MORNINGTHORPE AND FRITTON PARISH COUNCIL

East Pye Solar – EN0110014***Summary of MFPC Written Statement and Response to OFH2 Action Point*****Status and purpose of this summary**

RESPONSE TO OFH2 ACTION POINT – OMITTED RESIDENTIAL RECEPTORS

Figure 7.20 comparison between the Hedgerow and TPO plan showing Important Hedges Document 2.12 and the Preliminary Arboricultural Impact Assessment showing removal of Important Hedges and not reflecting TPO status fully.

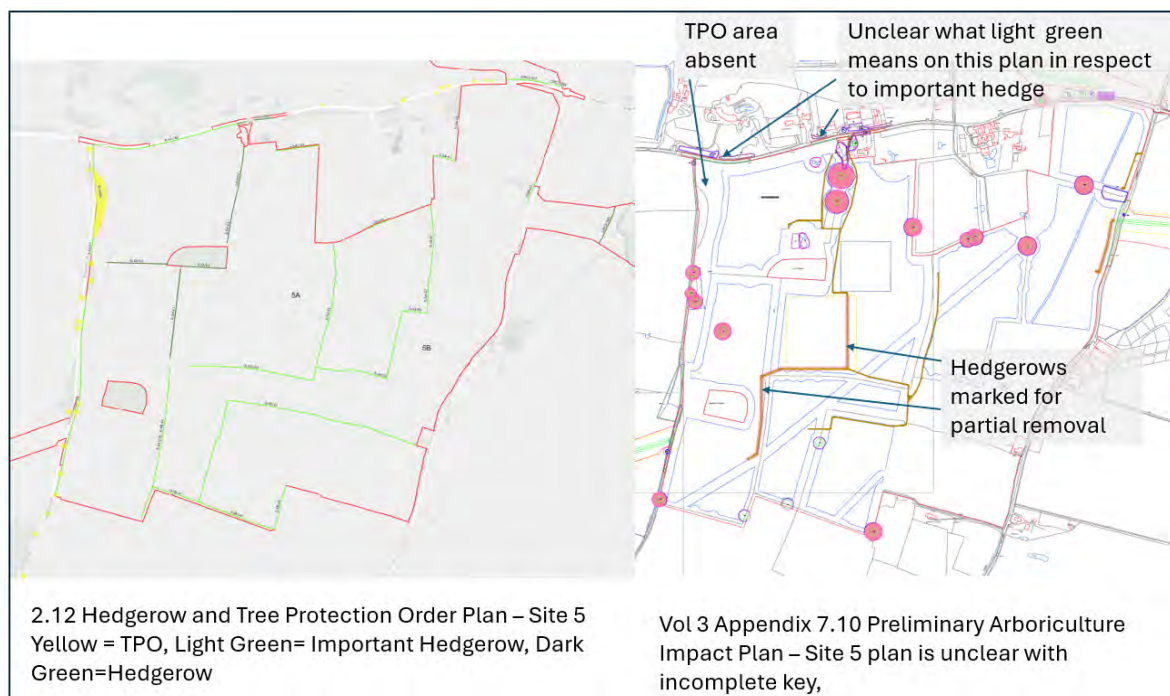
However, the Preliminary Arboricultural Impact Assessment (Environmental Statement Volume 3, Appendix 7.10) does not clearly identify this protected woodland within its assessment or provide specific recommendations relating to its protection. Given that these trees are subject to statutory protection, their omission from the principal arboricultural assessment is a significant deficiency.

Figure 8.11: Hydrological connections between Site 5 and the River Tas Adapted from East Pye Solar PIER Vol II.

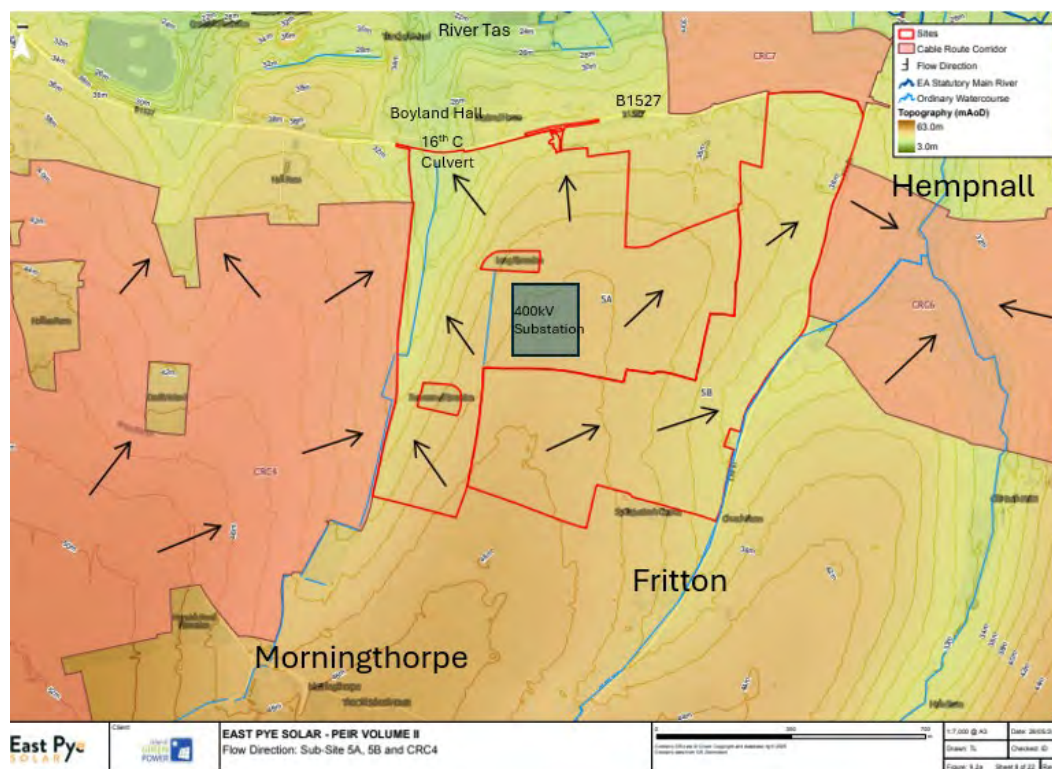
Figure 8.11 illustrates the hydrological connectivity between Site 5 and the River Tas, demonstrating that the development site contains a more extensive network of watercourses and drainage pathways than is represented within the Environmental Statement. These connections are ecologically significant because they provide direct pathways through which sediment, nutrients and contaminants could be transported to the River Tas during construction, operation and decommissioning.

Figure 9.12 Topographical Map showing the proposed 400kV substation has been sighted at the highest point in Site 5 meaning that any run off can flow in both directions into the watercourses and onto the River Tas.

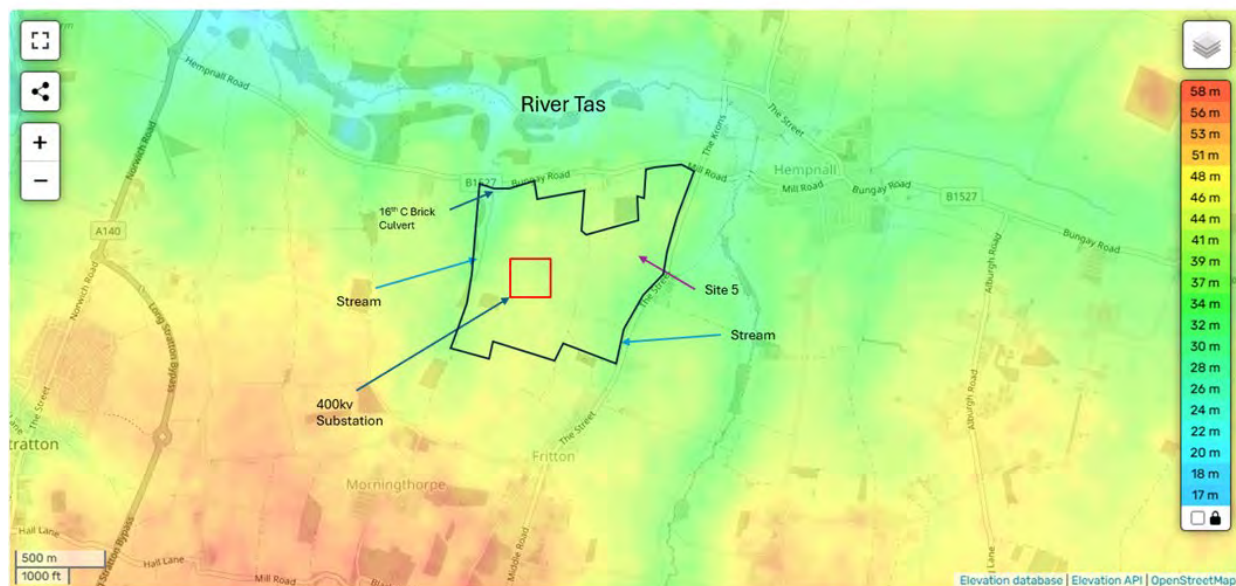
As illustrated in Figure 9.12, the proposed 400 kV substation is located on one of the highest points within Site 5. Surface water generated within this area has the potential to drain towards multiple watercourses connected to the River Tas catchment. Consequently, any accidental release of contaminants, increased sediment mobilisation or changes to local drainage patterns could affect both downstream watercourses and nearby groundwater-dependent receptors, including private water supplies.

Figure 12.3 Map of Site 5 showing locations of Residential Properties within 500m of Boundary.

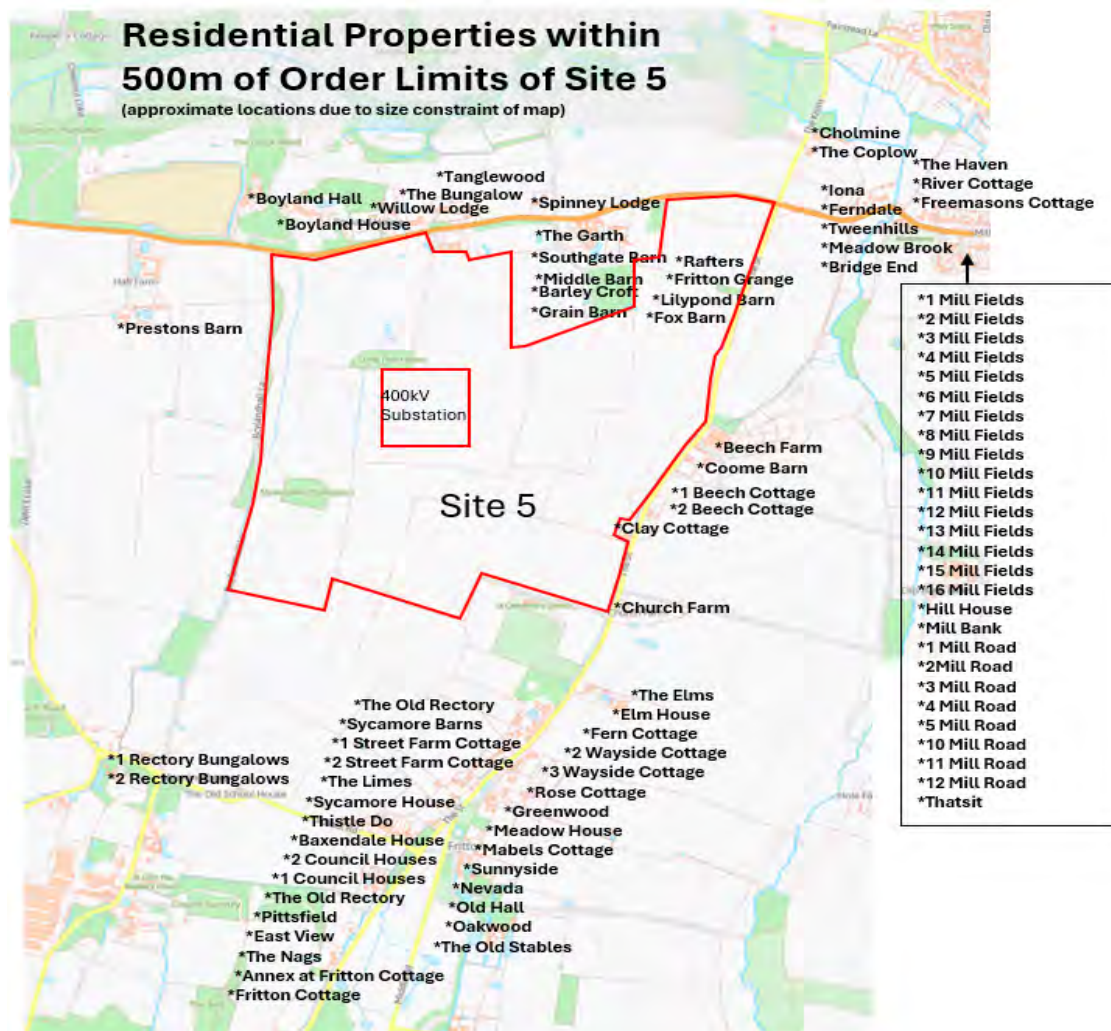
The map below has been marked up to show all the residential properties that fulfil the Applicants criteria for at least inclusion in the operational phase assessment due to being within 500m of the boundary to Site 5 as well as the location of the NSRs missed by the Applicant on the Northern boundary of Site 5.

Figure 12.4 Section covering Site 5 taken from The Works Plan showing position of infrastructure proposed for Site 5

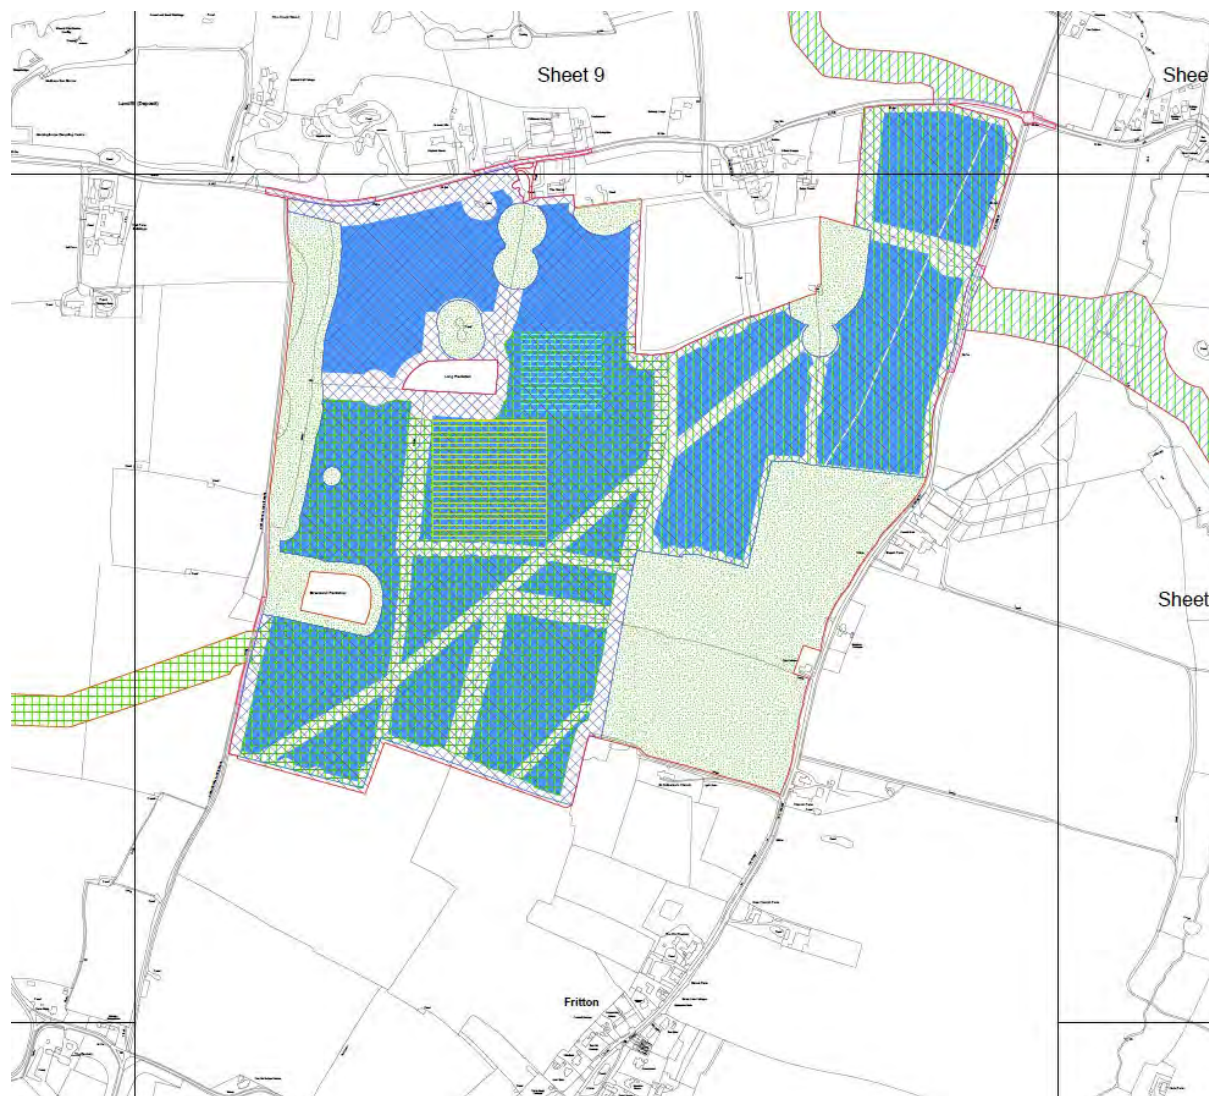
As can be seen from the Applicants plan below for the proposed infrastructure for Site 5 they have failed to identify and therefore assess the impact on all of the sensitive noise and vibration receptors.
